Air Resources Board

February 8, 2011 # 10-05

Thank you for your email dated September 24, 2010, requesting approval of the installation of E.J. Ward, Inc. RF Hose Module (HM), part # RF Hose Mod for the nozzle applications shown in Table 1.

Side Mount

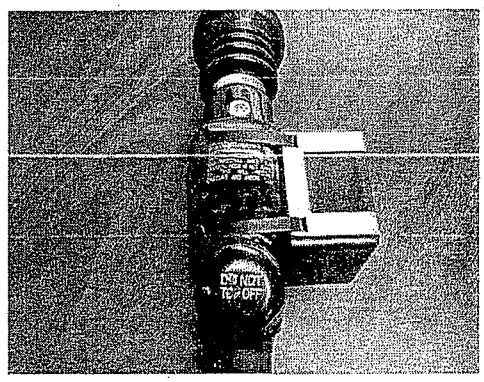
Air Resources Board (ARB) staff has reviewed all information and has completed a visual inspection. ARB staff verified through an engineering evaluation that side mount installation of the HM on the VST-EVR-NB Balance Phase II Vapor Recovery Nozzle and Emco Wheaton A4005EVR Vapor Recovery nozzle does not interfere with the nozzle boot or dispenser when hung or while fueling a vehicle. However, the HM is not approved to be mounted on the left side of the Healy 900 or 400 Phase II Vapor

Recovery Nozzle as it would block the vapor adjustment screw and breather hole located underneath the scuff guard.

ARB staff finds that the HM will not adversely affect the vapor recovery system when the HM is installed in accordance with E.J. Ward, Inc. recommended instructions. Therefore, the HM is approved for use on the Vapor Recovery nozzles listed in Table 1. In addition, ARB has received approvals of the HM from the Department of Food and Agriculture, Division of Measurement Standards, Department of Industrial Relations, Division of Occupational Safety and Health, Department of Forestry and Fire Protection and State Water Resources Control Board.

* HM is not approved for left side mounting of Healy 900 and 400 nozzles.
